PLAN SHOWING PROPOSED
BUILDING ON
PLOTS Nos 88A, 88B & 107 SHEET B-1
SERAI QR
SCALE 8"=1'

MUNICIPAL HEALTH OFFICER'S REPORT.

LAND SURVEYOR'S REPORT.

BUILDING SURVEYOR'S REPORT.

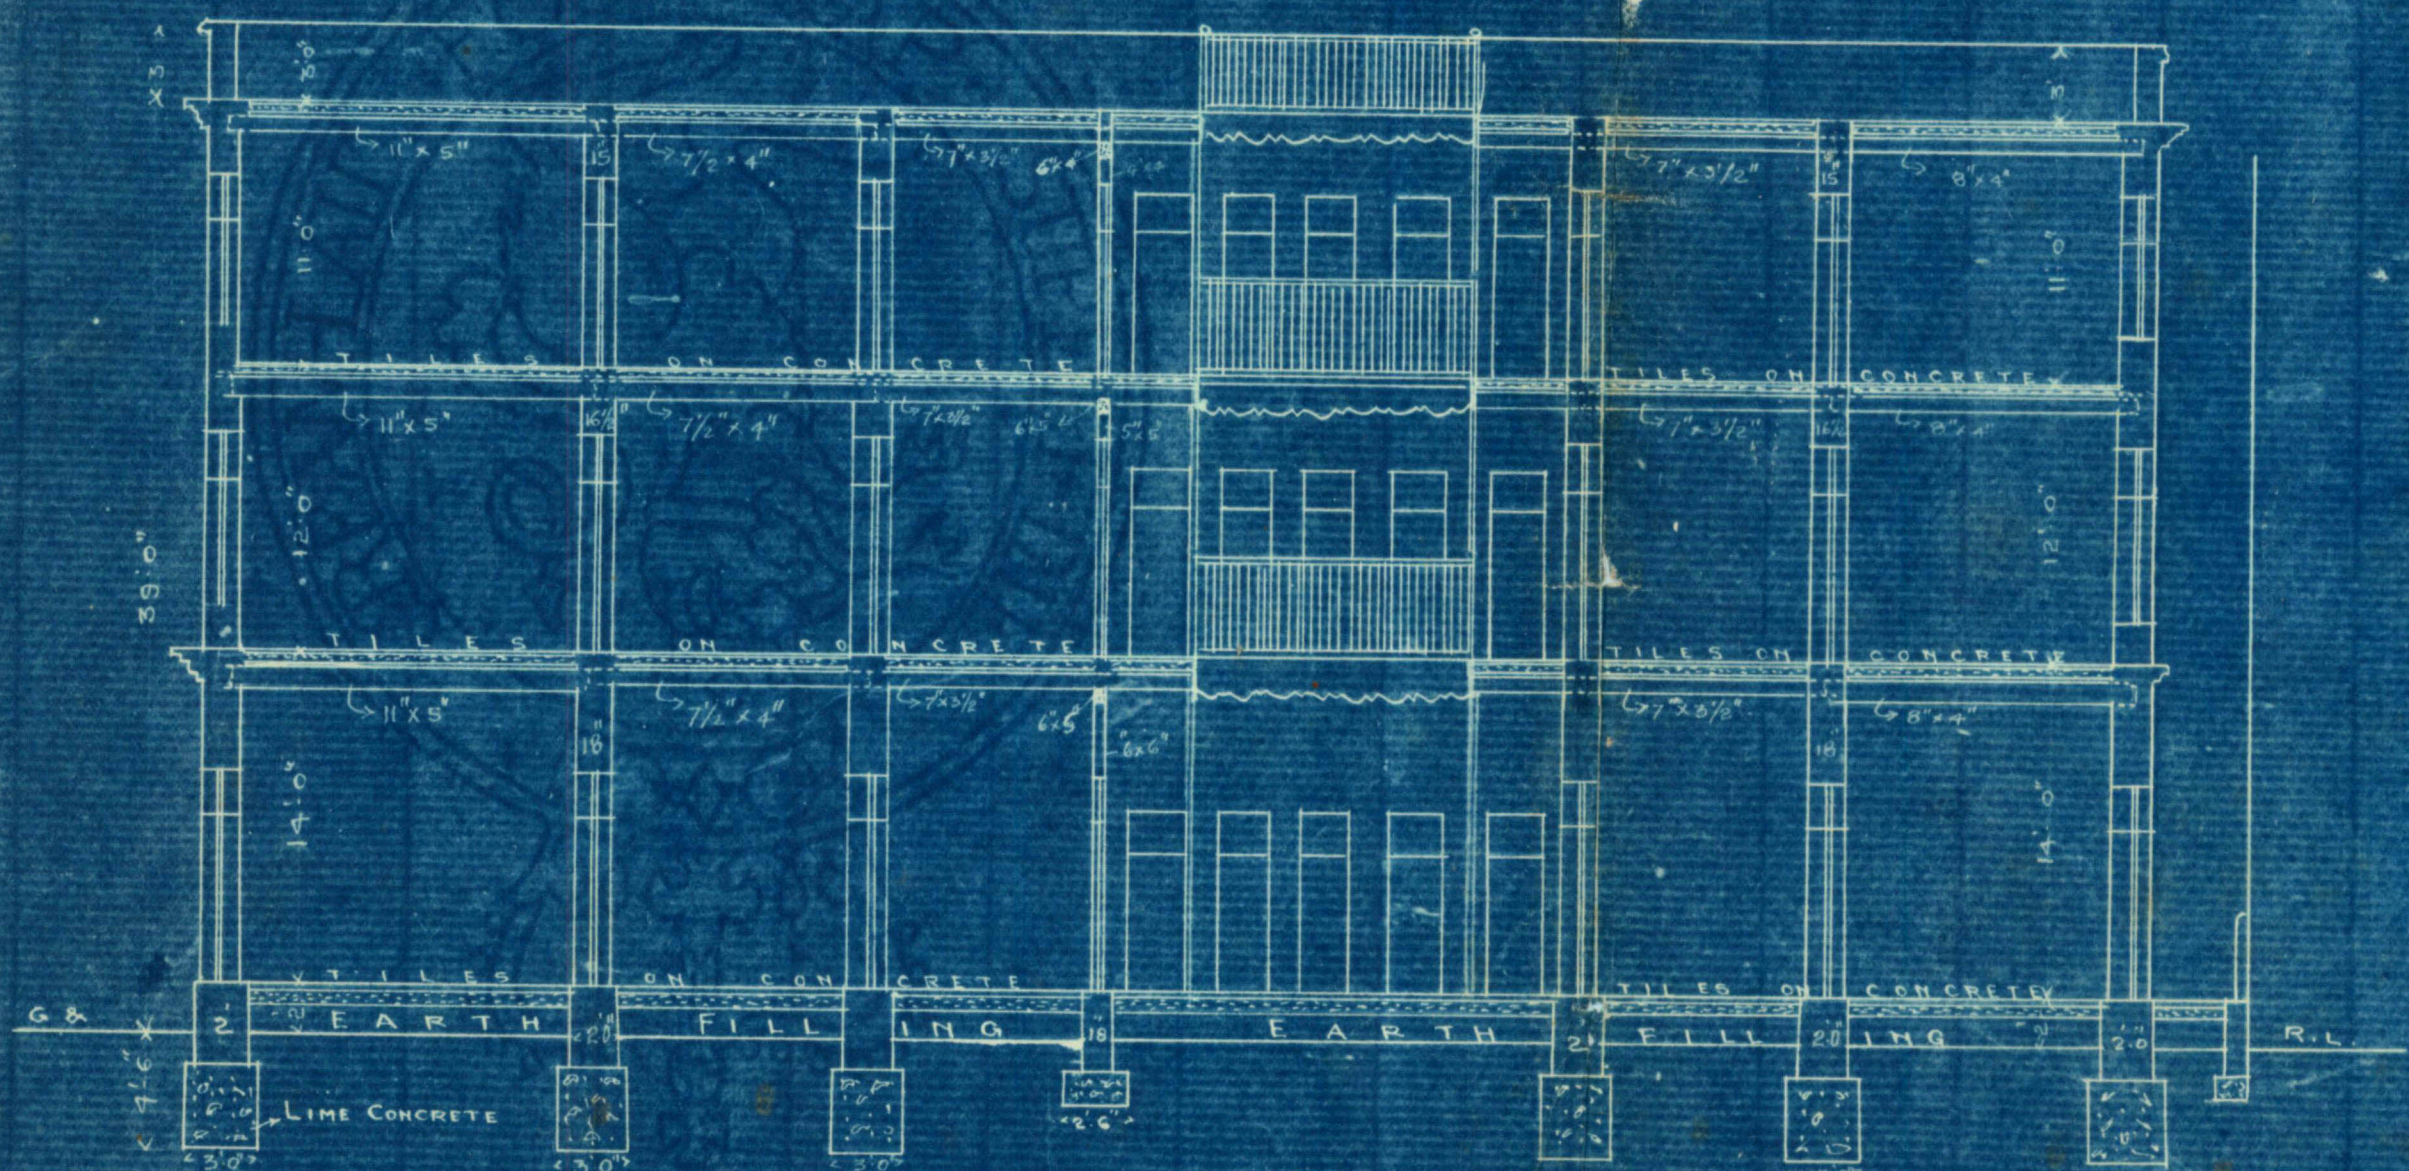
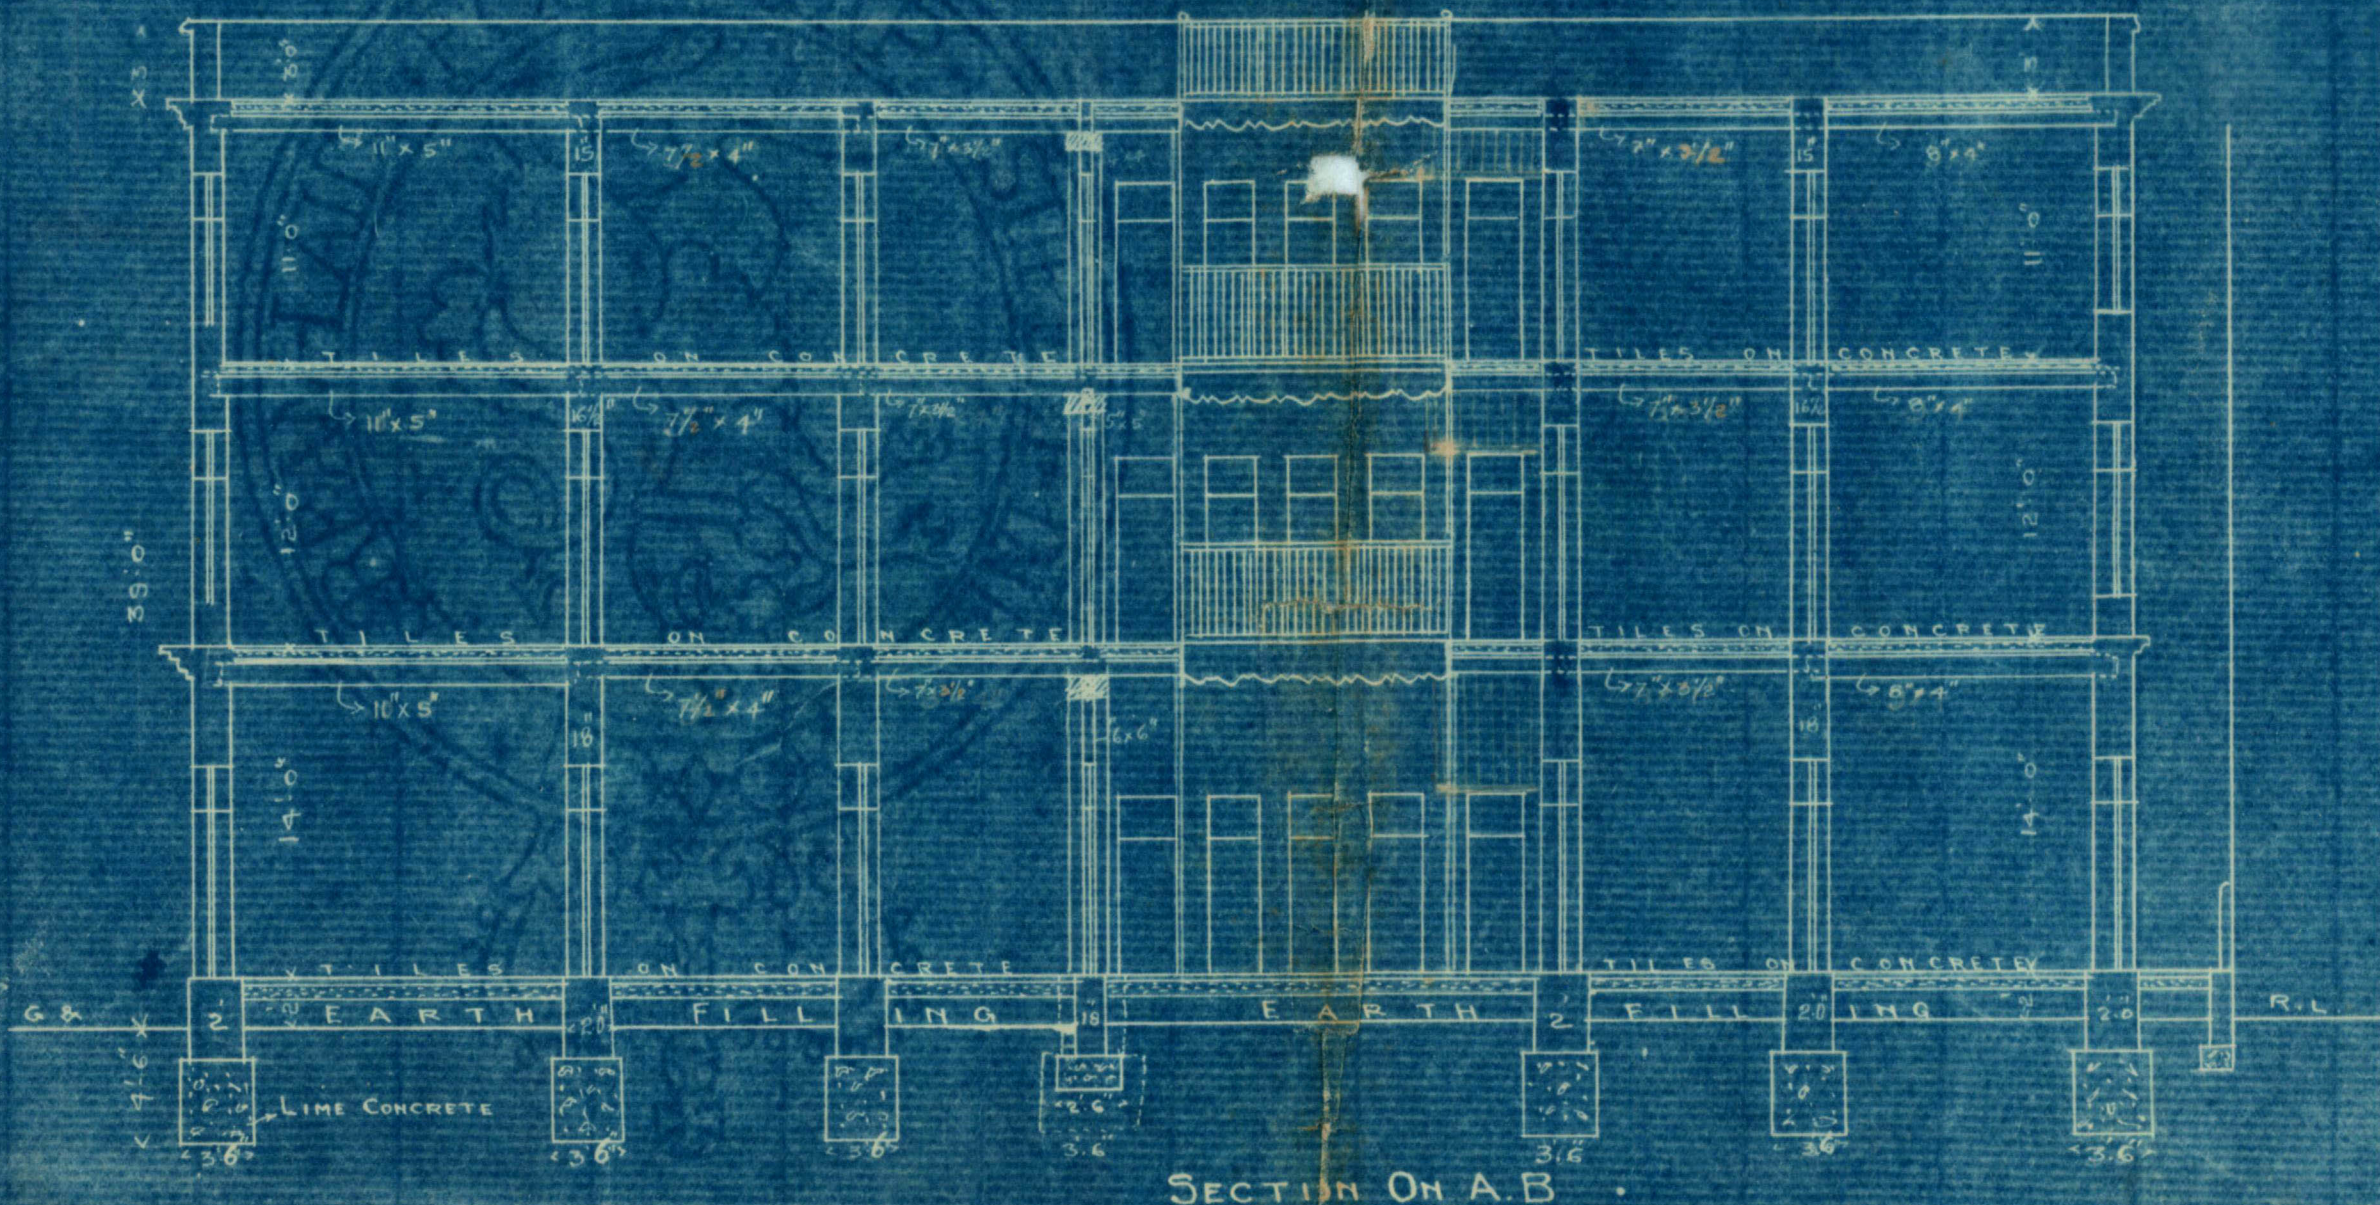
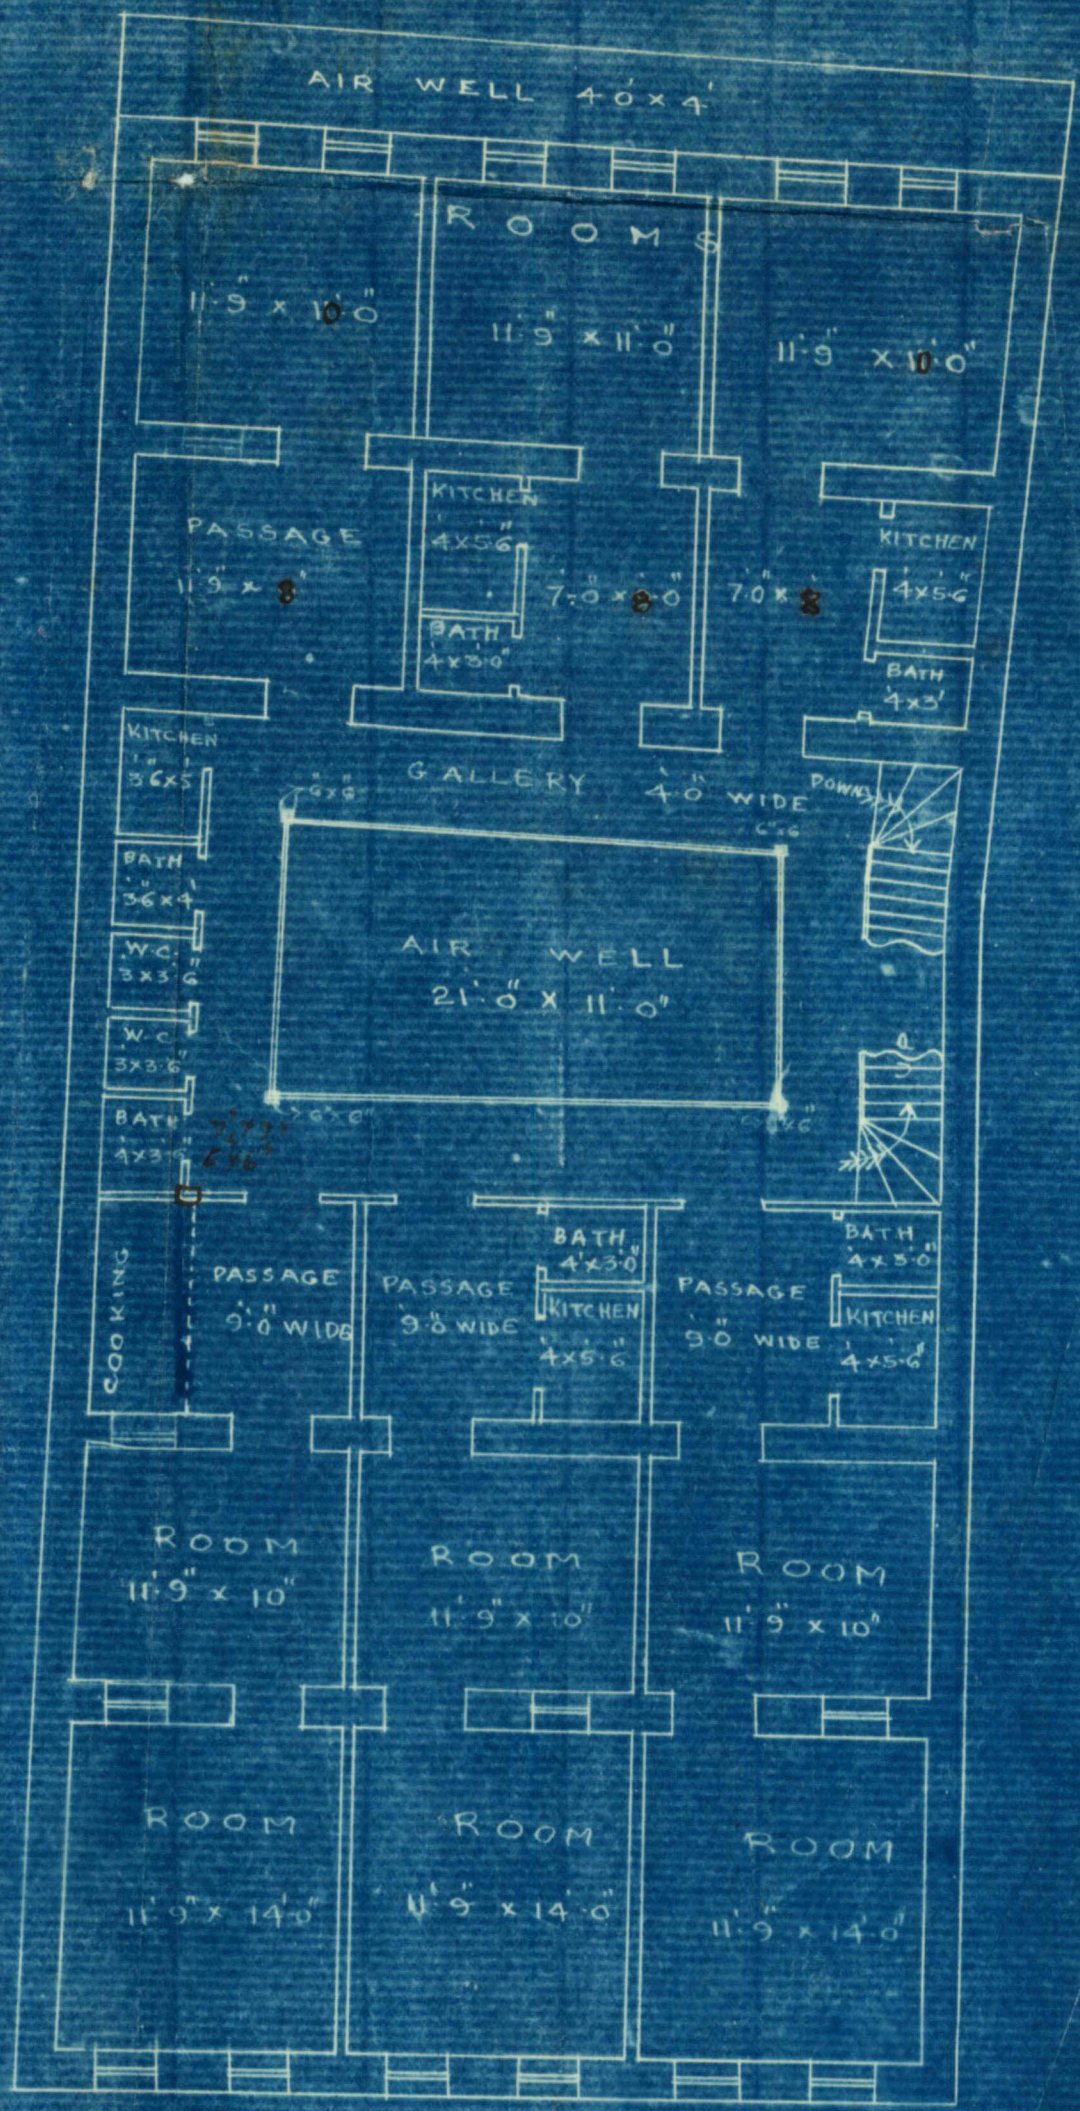
Br's doors + kitchen walls should be
7' & the front is about 5 1/2' to be fixed, windows
must be provided to the middle doors & ventilating
for rear rooms to allow cross ventilation
arrangement of pots should show a plan, pots
must be provided as shown on one of the blue prints

1. Outer wall should be built pucca
2. 12' x 7' beam should be provided below p. wall, 14 feet long.
3. ^{16' x 9'} beam must be provided below bath & w.c. p. walls.
4. Middle room will be dark
5. width of road should be 3'.
6. width of ground should be increased to 3' 6"
7. There will be no light in kitchen
